# Horsley Witten Group

May 4, 2015

Re: Nitrogen Loading Analysis – 100 Long Ridge Road, Carlisle

# Area of Impact (Systems 2 & 3)

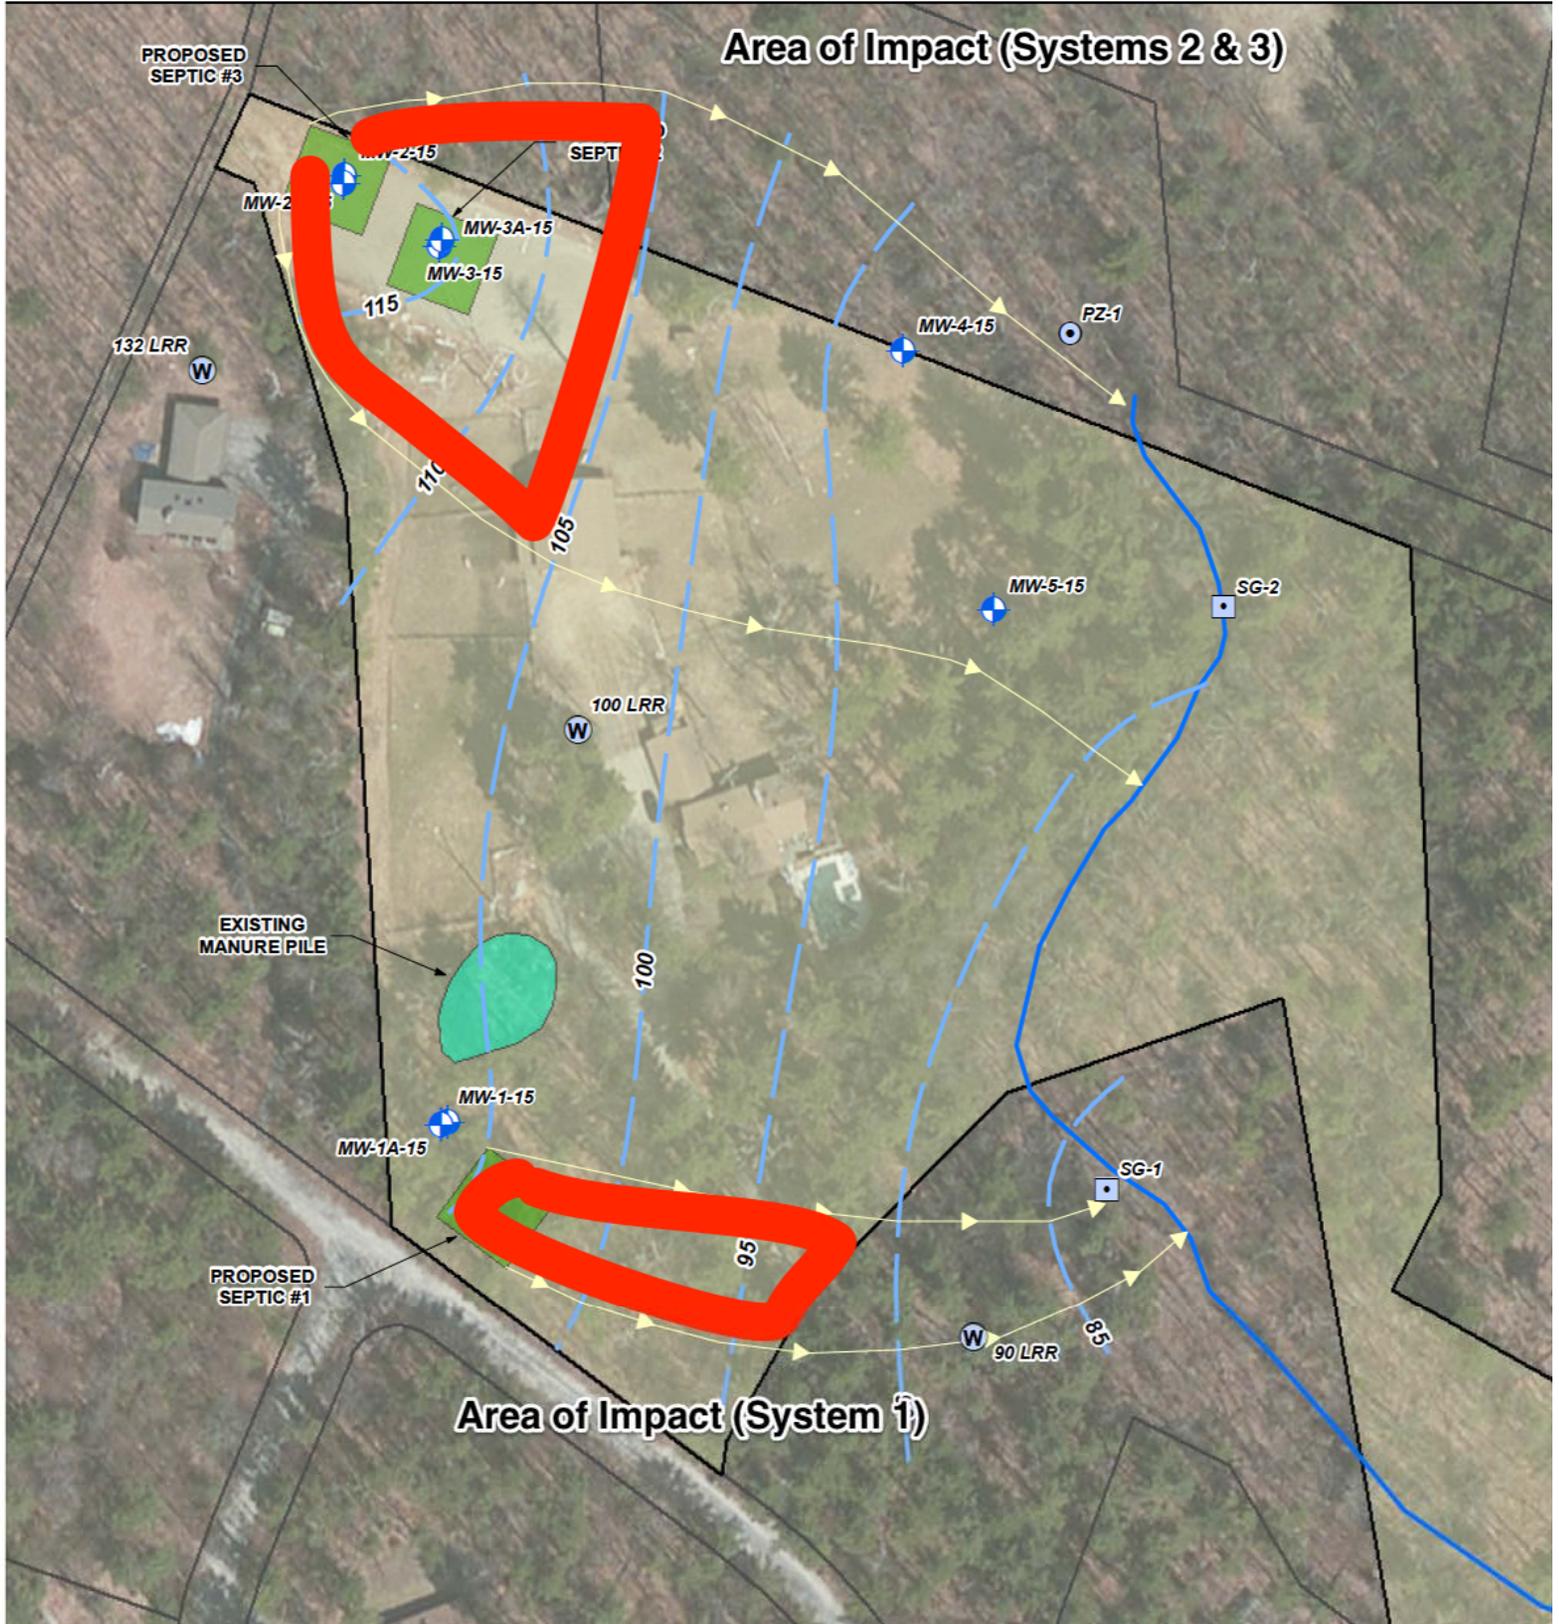
1. Area of Impact: Figure 6 of the NGI report shows groundwater flow conditions as a result of the proposed wastewater discharges. It shows that effluent from the proposed wastewater disposal area #1 flowing easterly and for areas #2 and #3 groundwater flows radially from the leaching areas in a northeasterly to southeasterly direction. This represents the Areas of Impact (AOI) as identified in the MADEP nitrogen loading guidance. See Figure 1 attached hereto.

4. Systems #2 and 3 Results: The NGI groundwater map shows that as the wastewater effluent leaves the proposed disposal area it fans out in a northeasterly to southeasterly flow direction. It also shows that the effluent and associated groundwater intersects a down gradient property boundary very close to the wastewater source along the northern property boundary. To determine the concentrations at this property boundary we have delineated an AOI that runs onto the down gradient and adjacent properties to the north. At the 105-foot water table contour on the NGI map this analysis predicts an average nitrate-nitrogen concentration of 17.1 mg/liter in this area. Higher concentrations of nitrogen can be expected at the down gradient property boundary closer to the wastewater disposal beds (for example in there are where the 110-foot contour intersects with the property boundary).
